# IMMINGHAM EASTERN RO-RO TERMINAL

Proposed Change Request Report

Document 10.3.11

November 2023

- 2.26 Figures 5 and 6 below show how the originally submitted scheme would be amended if this Proposed Change 3 is accepted.

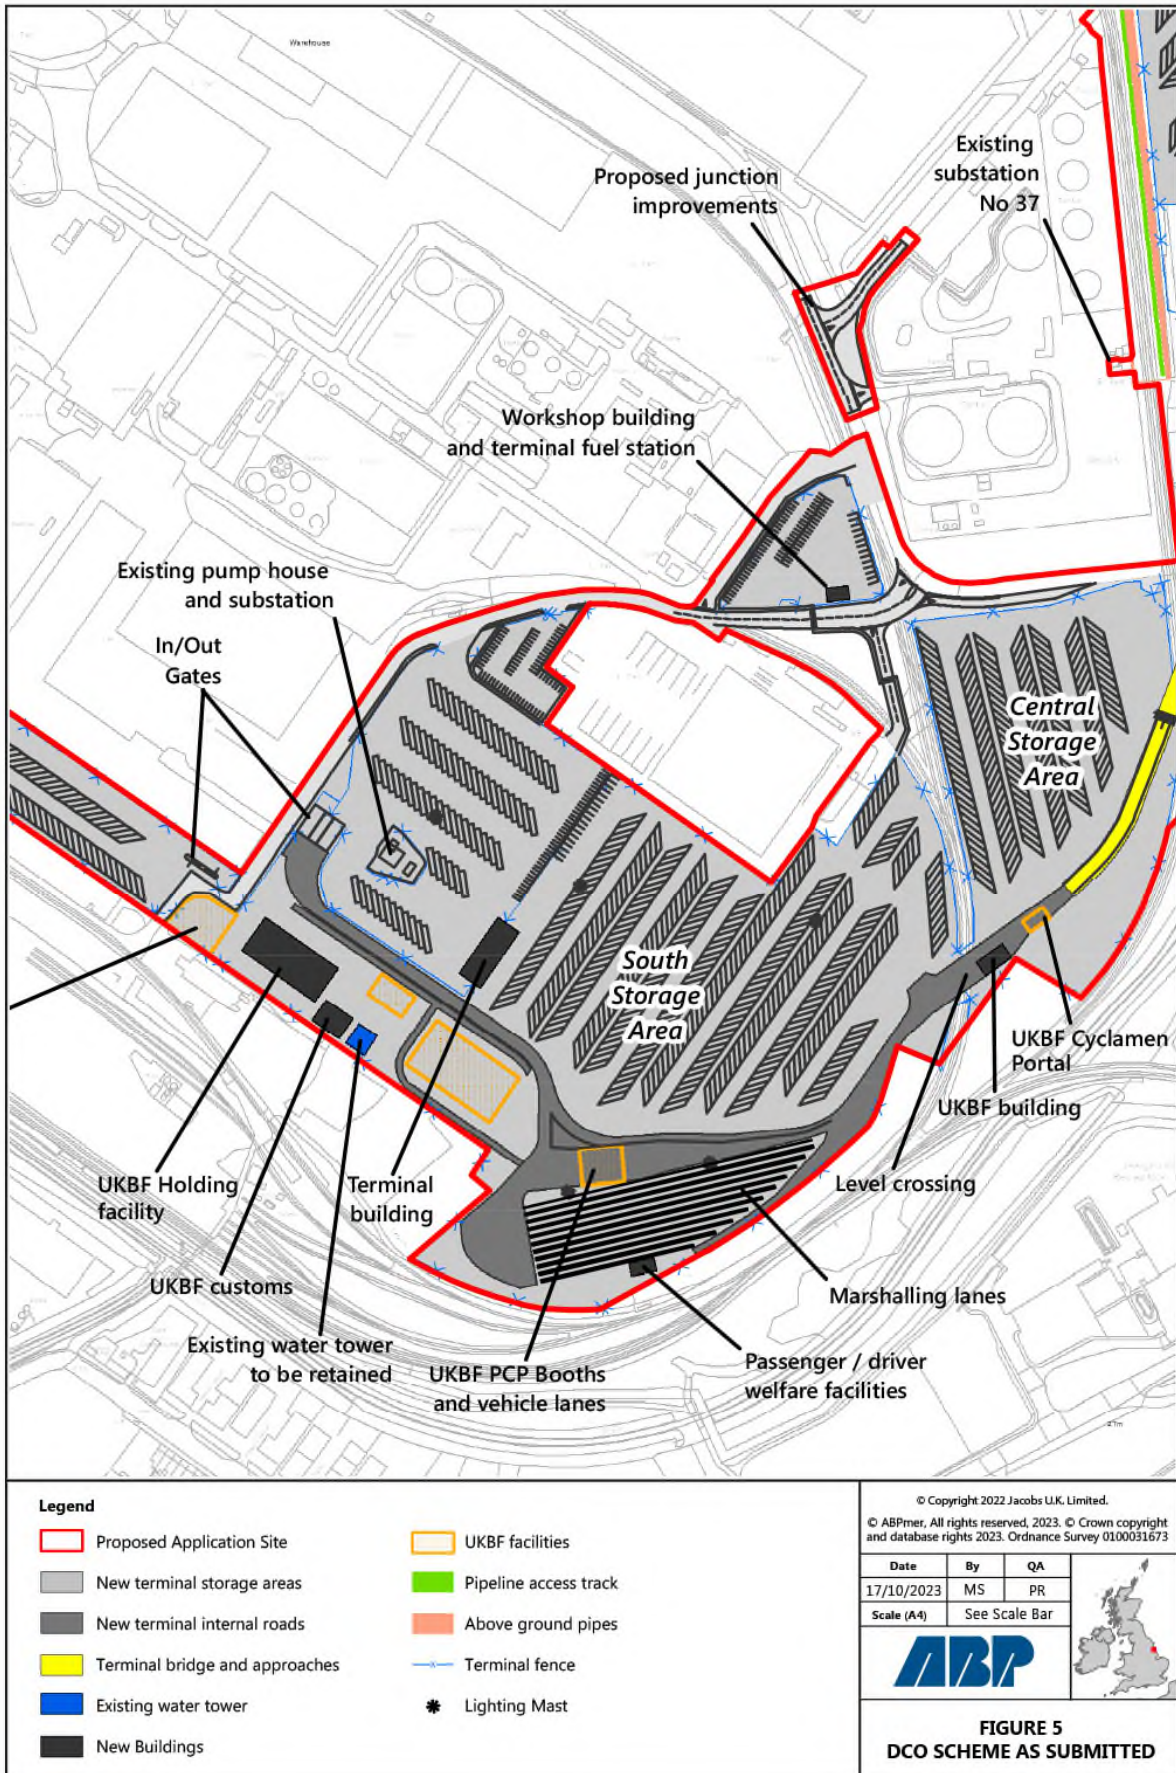
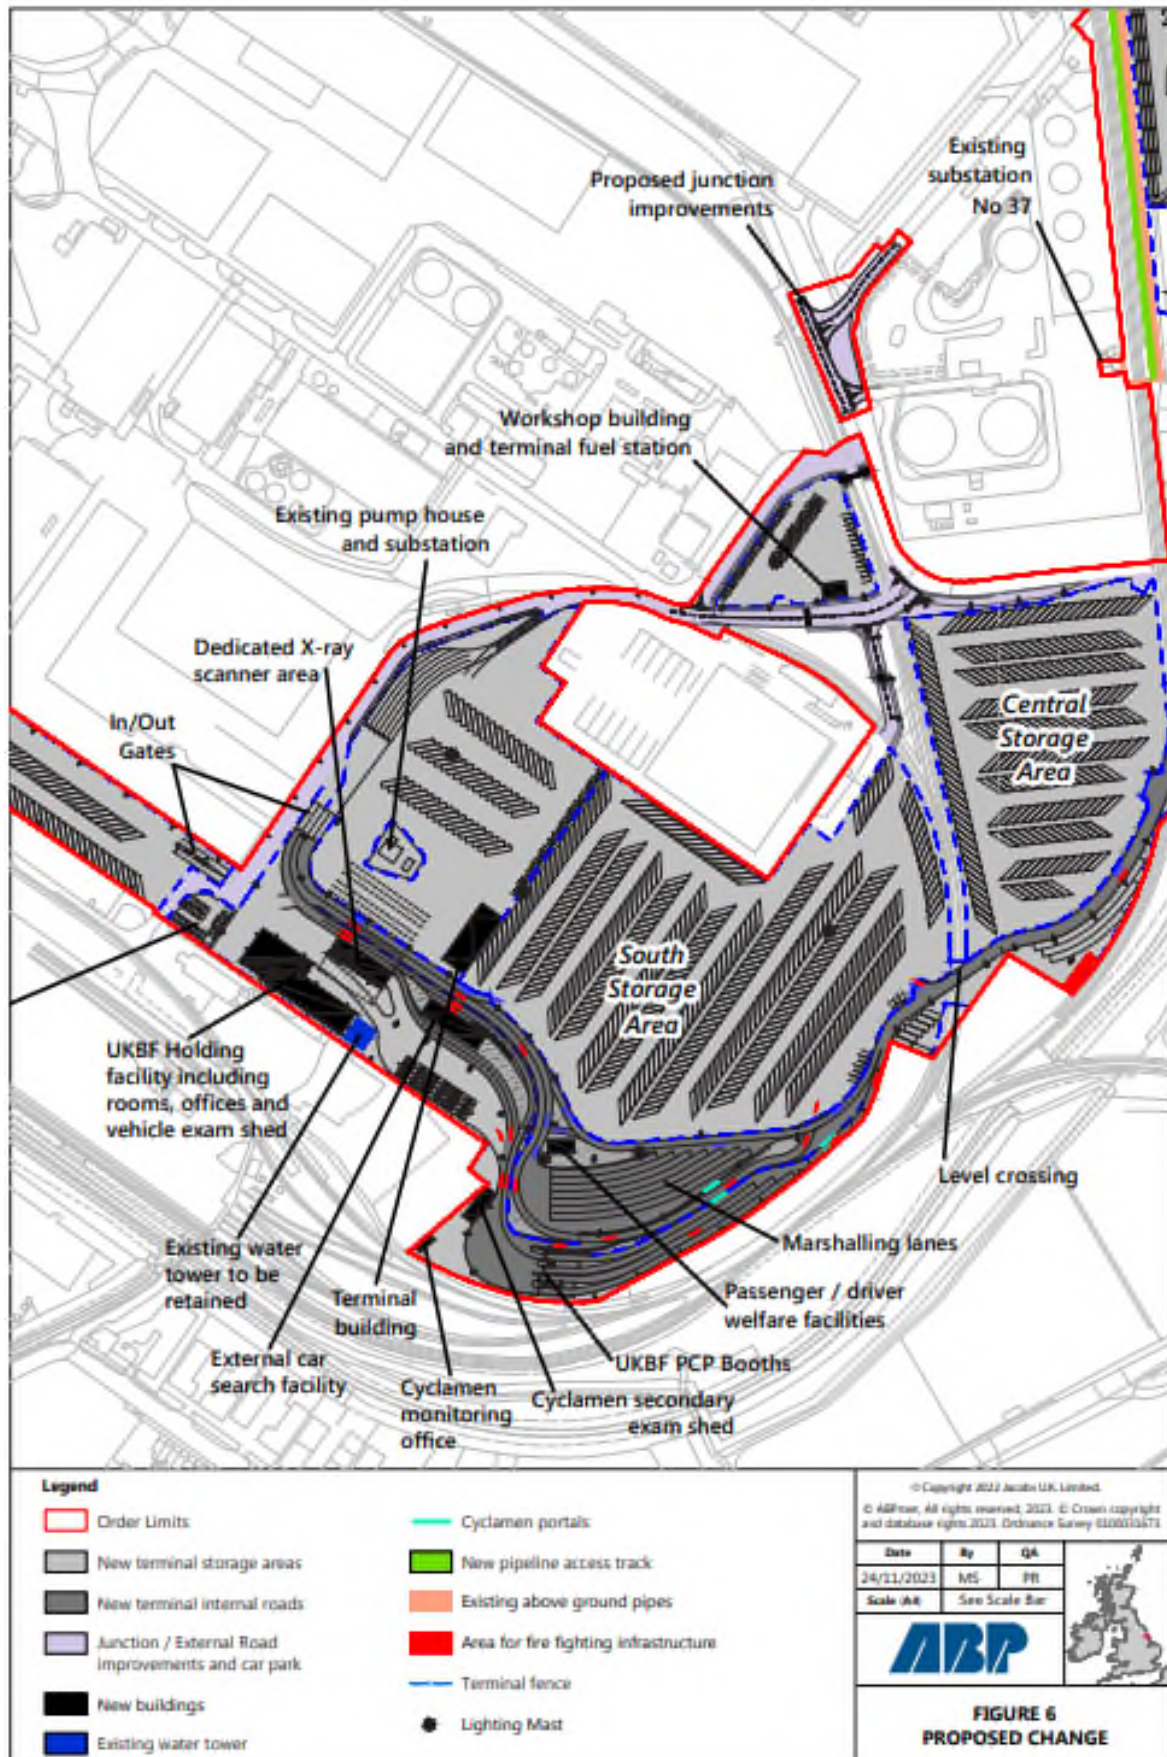
- 2.24 If Proposed Change 3 is accepted into the examination, the area within which the UKBF facilities will be located, i.e., the Southern Storage area, will not change in terms of the area required. What will change is the general layout, location and precise of the facilities required by UK Border Force to enable them to undertake their duties in terms of both cargo entering and leaving the Port.

Figure 7 – Change to the Conditional Proposed Impact Protection Measures

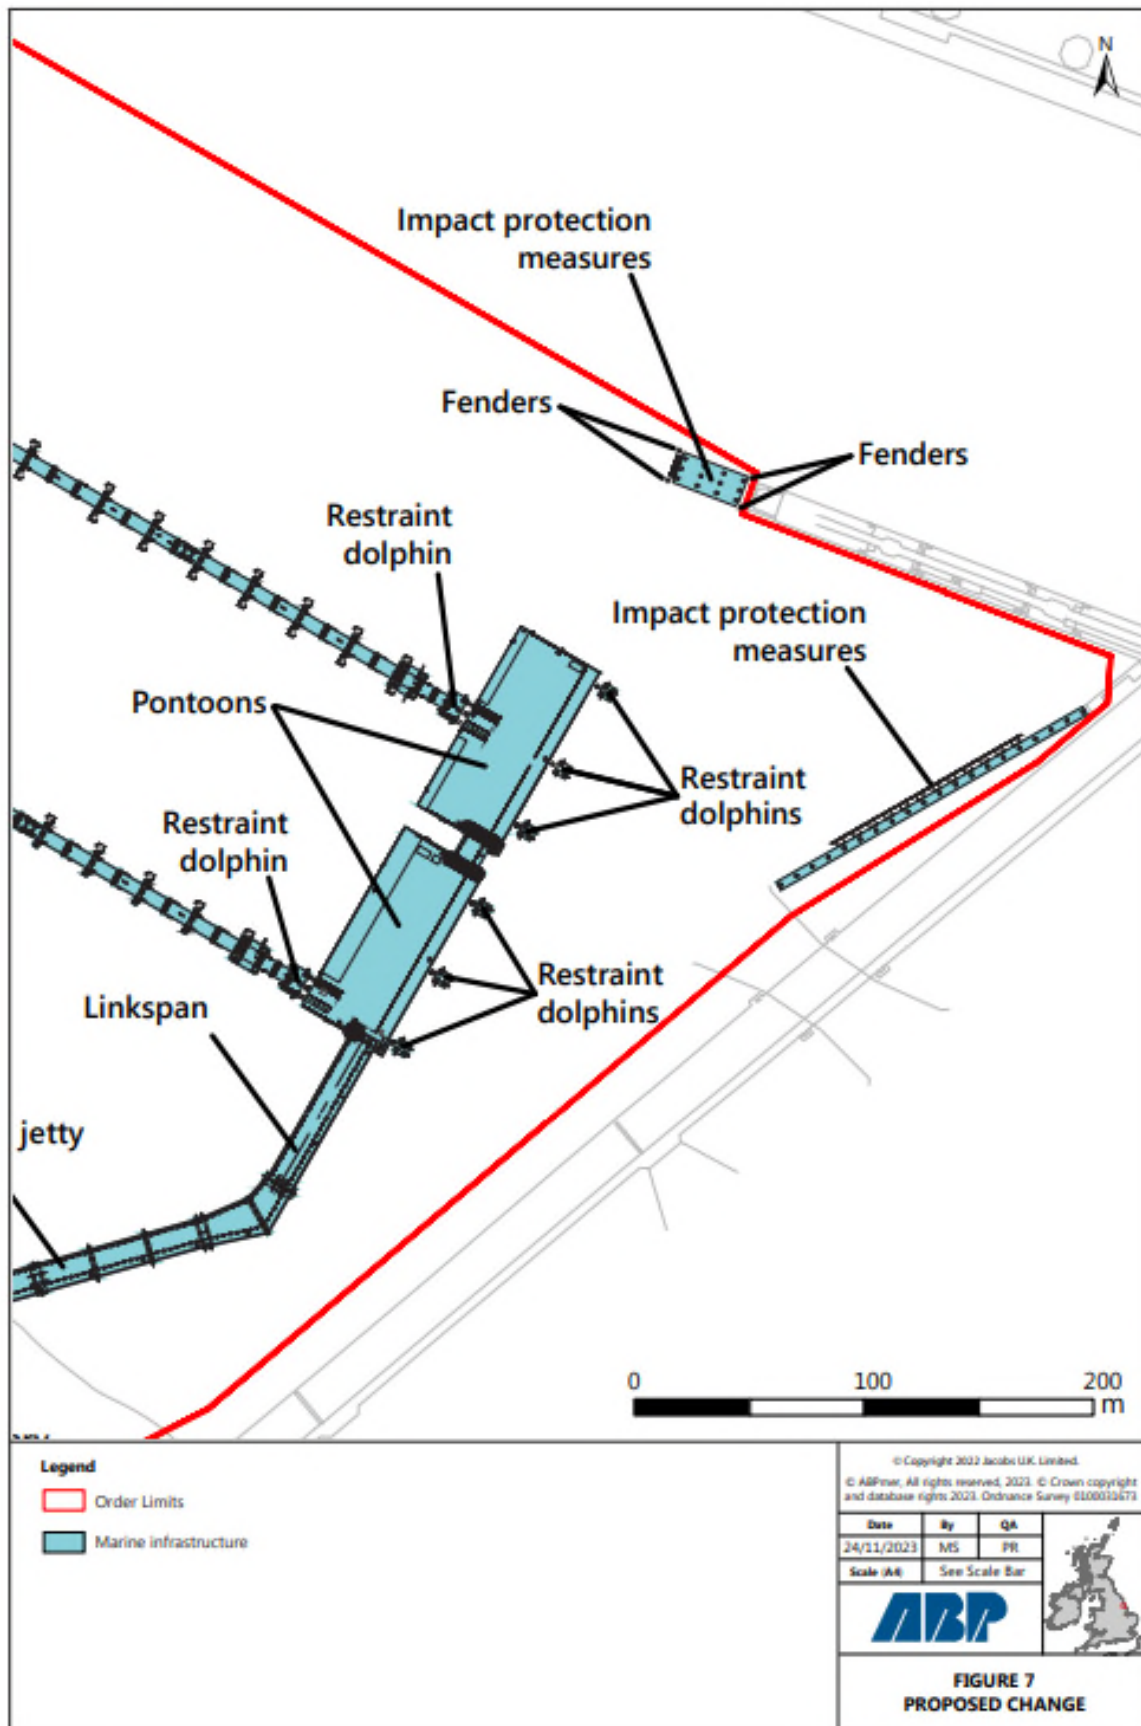
- 2.46 **Impact Control Measures** – The draft DCO will, if the Application is accepted, also be amended in two further respects –
- a) **Linear protection** – Whilst the Applicant will retain the conditional provision of the linear protection barrier for the IOT trunkway as already identified in Schedule 1 of the submitted DCO application, (Work No. 3 as shown on the General Arrangement Plans) albeit with an important change, namely that the pile diameter will be increased from 1,422 mm to 1,520 mm;

- 2.47 The second change is that whilst the provision of impact protection measures remains conditional on a recommendation by the Statutory Conservancy and Navigation Authority (“SCNA”), as detailed in Requirement 18 of the draft DCO, it is also proposed to amend Requirement 18 to include the Port of Immingham Dock Master as well as the SCNA.

- a) The Applicant will retain the conditional provision of the linear protection barrier in front of the IOT trunkway (Work No. 3) as identified in the submitted General Arrangement Plans, **[APP-009]** although, to assist the IOT Operators in terms of confidence as to the resilience of the linear protection barrier, the pile diameter will be increased from 1,422 mm to 1,520 mm; and

- b) The Applicant will also, however, as part of the Proposed Change, if accepted by the ExA, amend the submitted draft DCO and plans to include, again conditionally, the provision of an additional impact protection barrier to the west and in front of the IOT finger pier.

Figure 8 - Beckett Rankine scheme

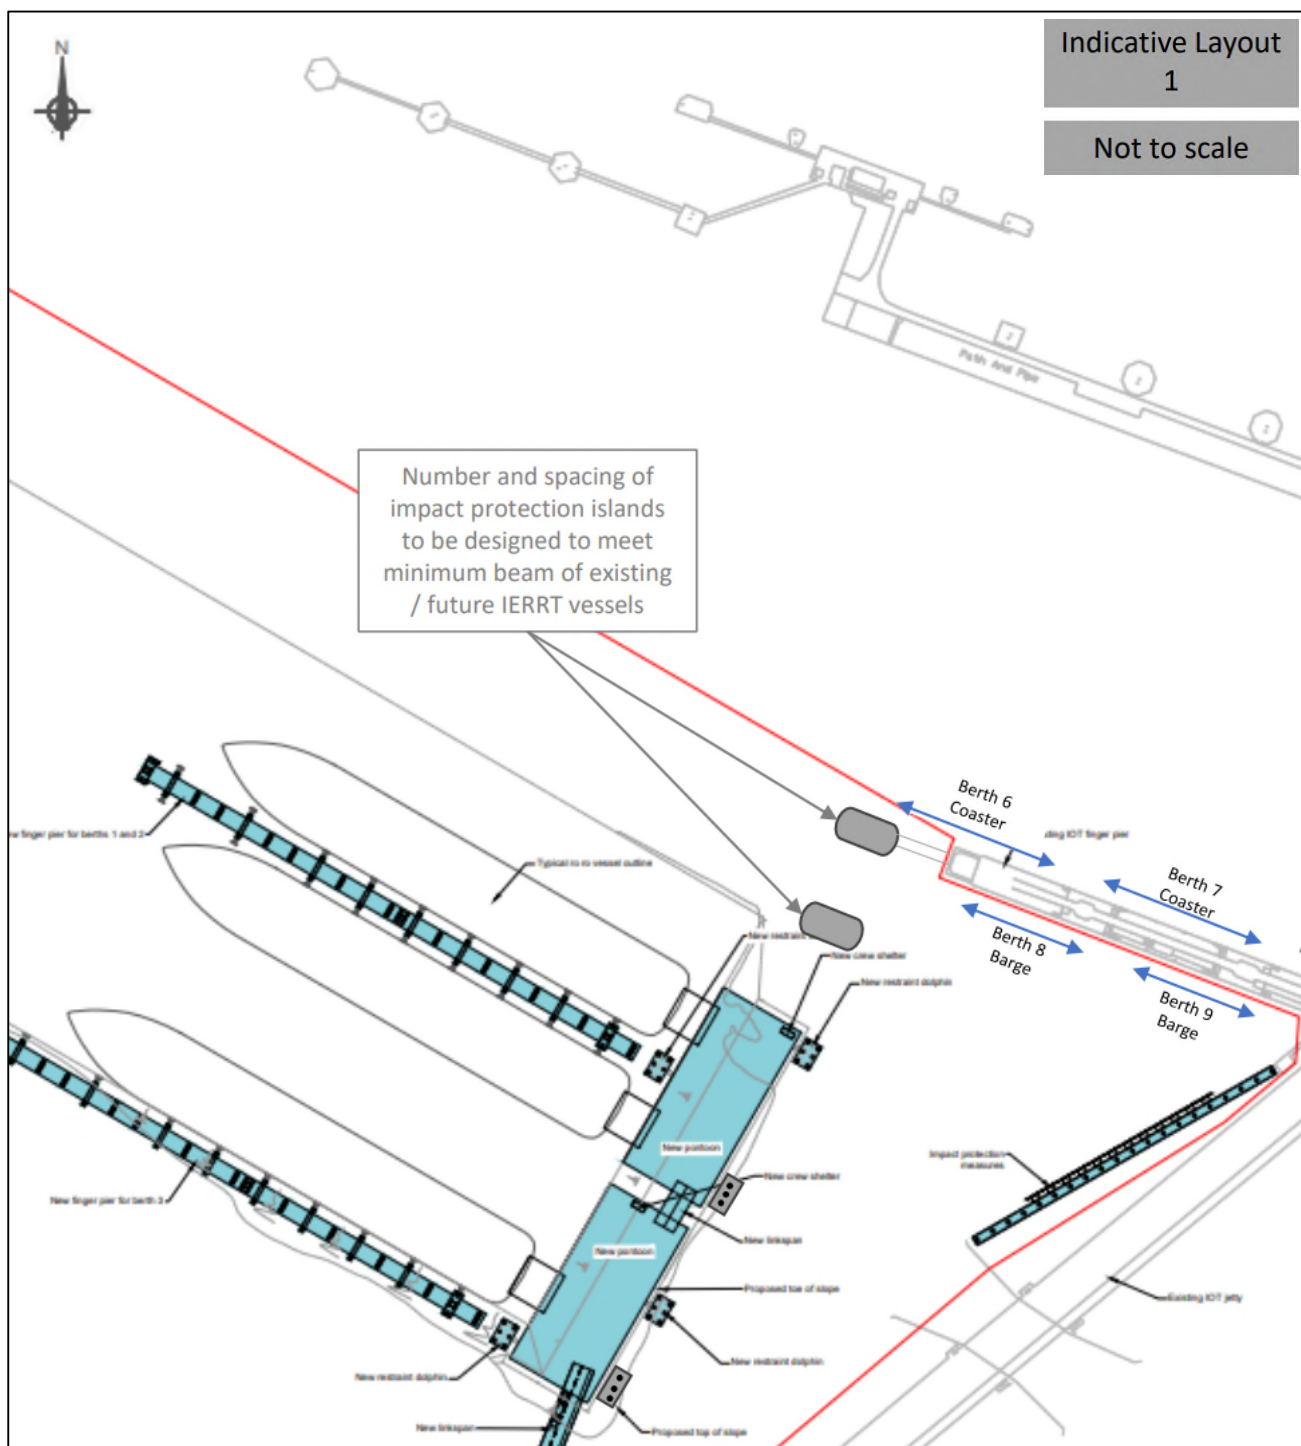
- 3.23 A plan of the original “high level” Beckett Rankine scheme is provided at Figure 8 below.

- a) **The size of the impact protection structures** – the requirement to design impact protection structures to accommodate the largest design vessel travelling at a maximum current speed of 4 knots resulted in a plan area of each impact protection structure in the order of 45m long by 25m wide by 30m high. This compares to an approximate size of 20m by 10m as shown in the Beckett Rankine scheme. One impact of such a significant size increase would be the introduction of a significant additional navigational constraint, to both IOT and the proposed IERRT operations.
